03-284646
PERMIT

A REPAIR

SEWAGE DISPOSAL SYSTEM
MARYLAND STATE DEPARTMENT OF HEALTH*

ADDRESS 1720 Woodstock Road, Woodstock, Md. 21163

INDICATE NORTH. - NAME ADJOINING ROADWAY AS BASE LINE.

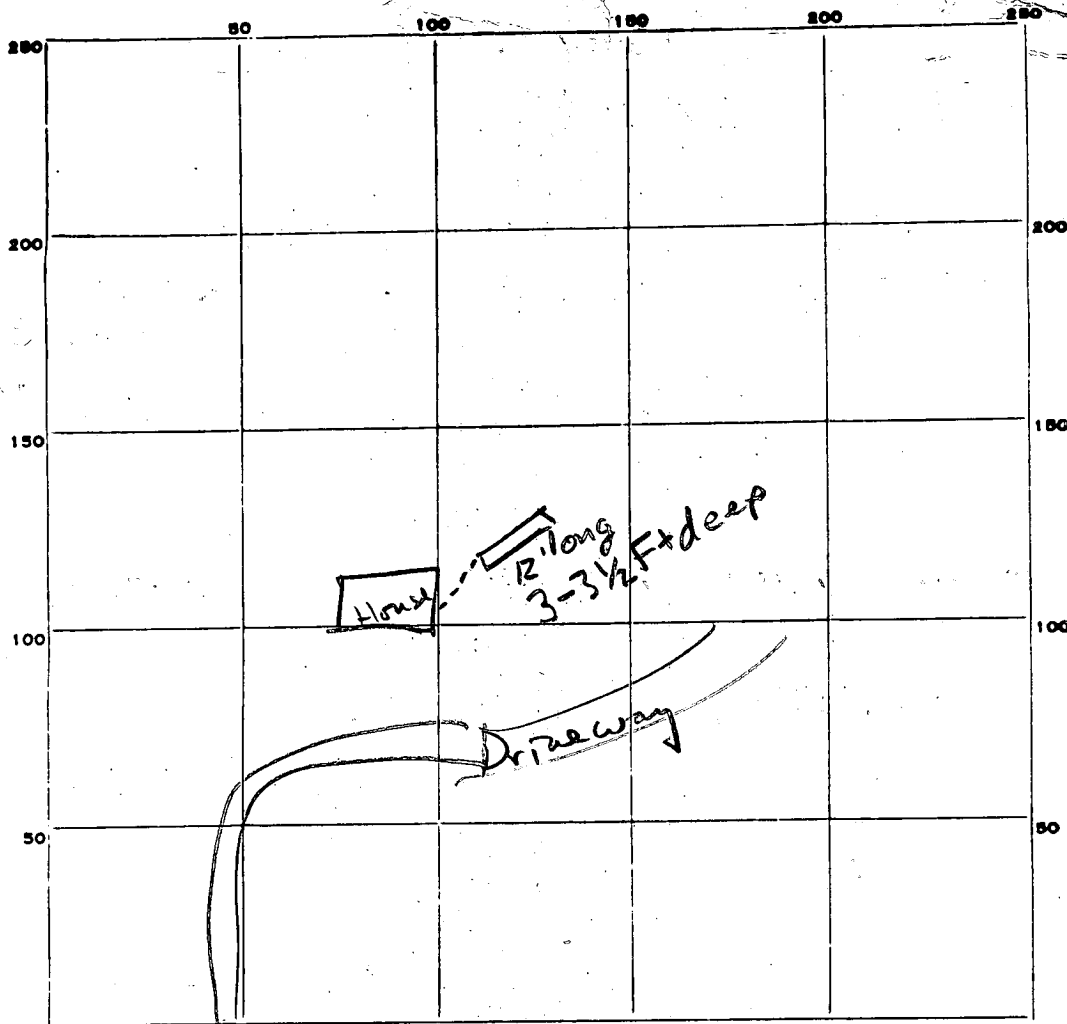
REMARKS Temporary trench only; Make trench longer +/or deeper. Put in stones to 10" below top. Put perforated pipe in at 10" with stones to cover. That leaves 6". Call for insp. before putting on paper and the last 6" of dist. WS 4/20/79
